REGIONAL REVIEW FINDING

ARC REVIEW CODE: R2002171

Name of Proposal: Bright Star Connector (DRI #3027) <u>Submitting Local Government</u>: City of Douglasville <u>Review Type</u>: Development of Regional Impact <u>Date Opened</u>: Feb. 19, 2020 <u>Date Closed</u>: March 9, 2020

BRIGHT STAR CONNECTOR DRI City of Douglasville Natural Resources Group Review Comments February 17, 2020

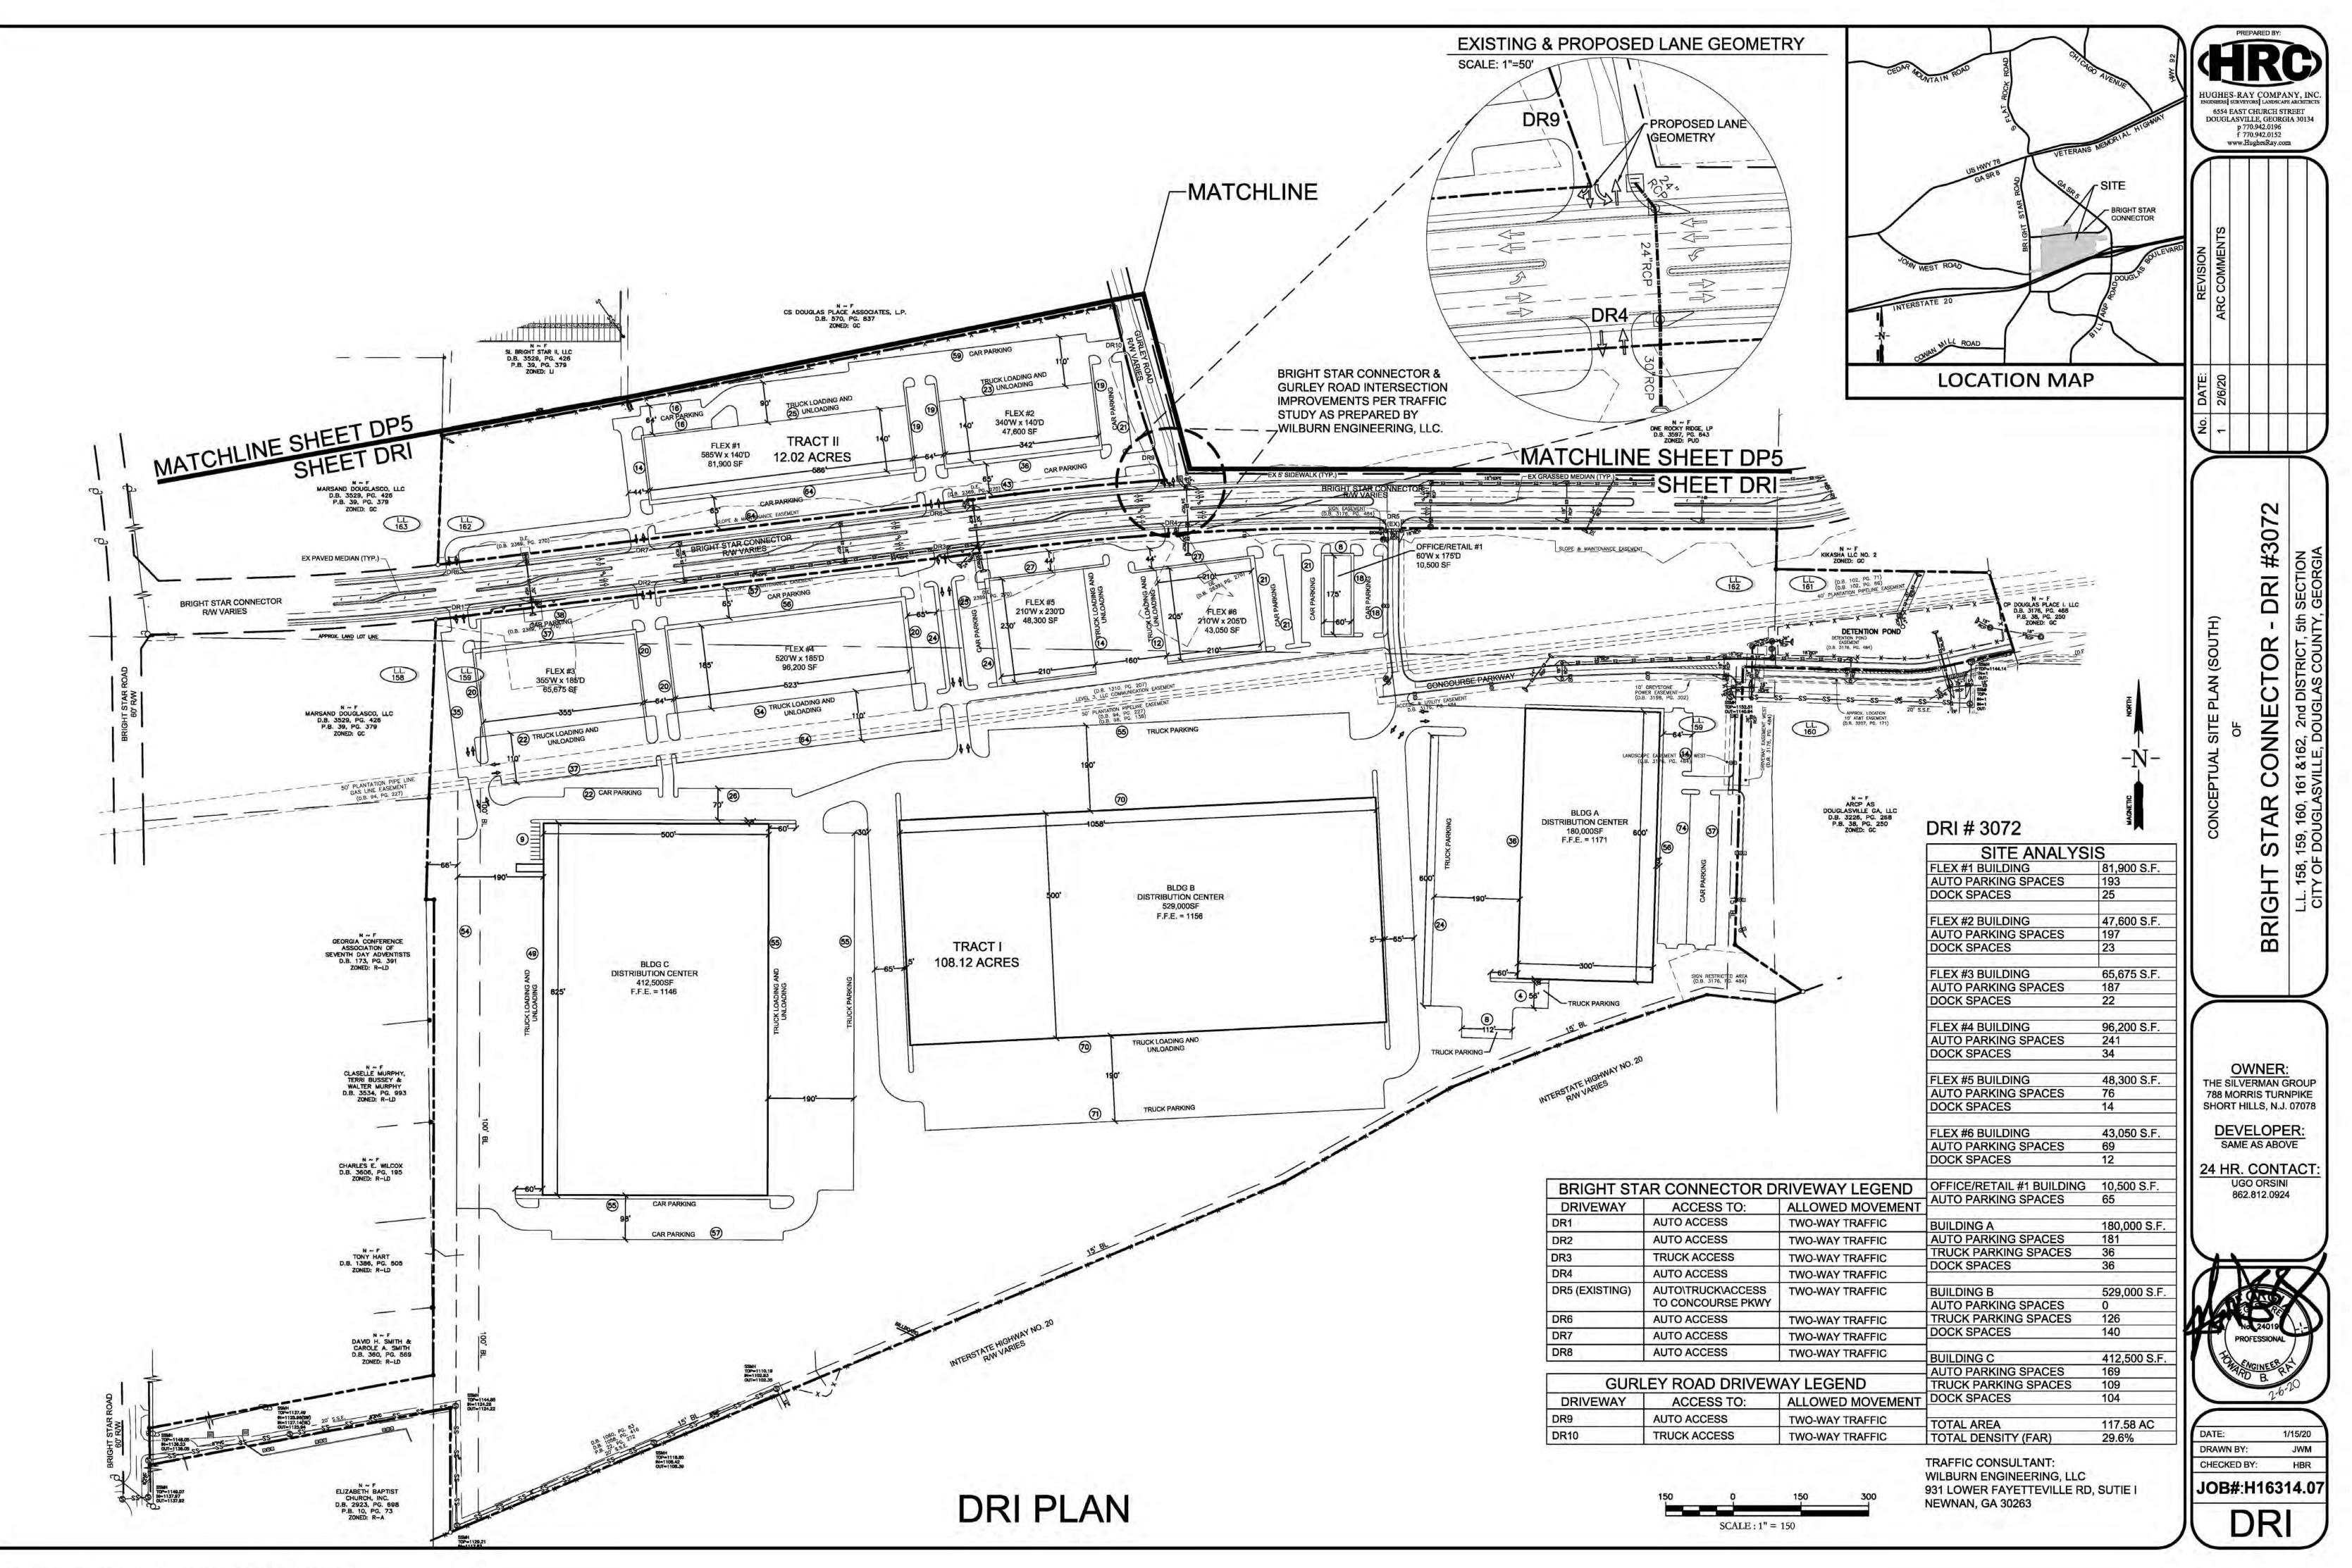
The USGS coverage for the project area shows a dashed blue line (intermittent) stream and branch running northsouth through the center of the project property. The project site plan shows the stream as starting at the eastern edge of the property, just east of a proposed driveway/parking area. The submitted site plan shows no indication of these streams and it appears both buildings and parking areas will be built over the streams and will intrude on the City's 50-foot stream buffer and additional 25-foot impervious setback. Any intrusion in the buffer or setback will be subject to the requirements of the City of Douglasville's Stream Buffer Ordinance. Any unmapped streams on the property may also be subject to the requirements of the City's Stream Buffer Ordinance. In addition, all streams on the property, as well as all waters of the state, are subject to the requirements of the State Erosion and Sedimentation Act, which includes a 25-foot buffer on all state waters.
